DEVELOPMENT ASSESSMENT REPORT				
<b>Application No.</b>	DA/2022/0879			
<b>Address</b>	595 King Street NEWTOWN			
<b>Proposal</b>	Alterations and additions to existing shop top housing including additional unit and rooftop open space.			
<b>Date of Lodgement</b>	17 October 2022			
<b>Applicant</b>	JRU Partnership			
<b>Owner</b>	JLV Properties Pty Ltd Romeli Property Group Pty Ltd Unicorn Projects Pty Ltd			
<b>Number of Submissions</b>	Initial: 0			
<b>Value of works</b>	\$246,729.00			
<b>Reason for determination at Planning Panel</b>	Section 4.6 variation exceeds 10%			
<b>Main Issues</b>	<ul style="list-style-type: none"> <li>• Breach of height of building development standard</li> <li>• Breach of floor space ratio development standard</li> <li>• Heritage and Streetscape</li> <li>• Internal amenity</li> </ul>			
<b>Recommendation</b>	Refusal			
<b>Attachment A</b>	Reasons for refusal			
<b>Attachment B</b>	Plans of proposed development

This report is an assessment of the application submitted to Council for alterations and additions to existing shop top housing including an additional unit and rooftop open space at 595 King Street NEWTOWN.

Figure 8; Setbacks from King Street at 601-603 King Street.

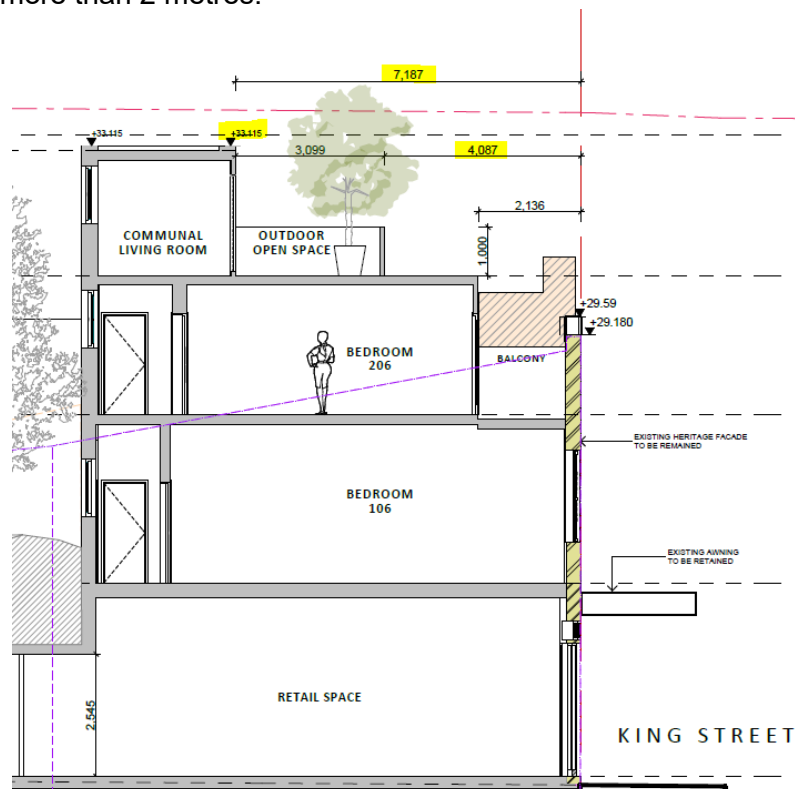
As shown in Figure 5 below, while the balustrade for the outdoor space at No. 601-603 King Street is only set back by 4.1 metres, the communal living room is set back by more than 7.187 metres from the front. In addition, the height of the communal living room does not exceed RL33.115. As outlined above, the balustrade of the proposed communal open space at No. 595 King Street is set back from the front by only 6.3 meters and the top of the balustrade is approximately at RL35.233, exceeding the height of the communal living room at No. 601-603 King Street by more than 2 metres.

The front setback of the proposed additional apartment (~5m), excluding the balcony, is significantly less than the front setback of the communal living room at No. 601-603 King Street. Further, the height of the proposed apartment is approximately 100mm higher than the top of the communal living room at No. 601-603 King Street. As such, it is considered that the
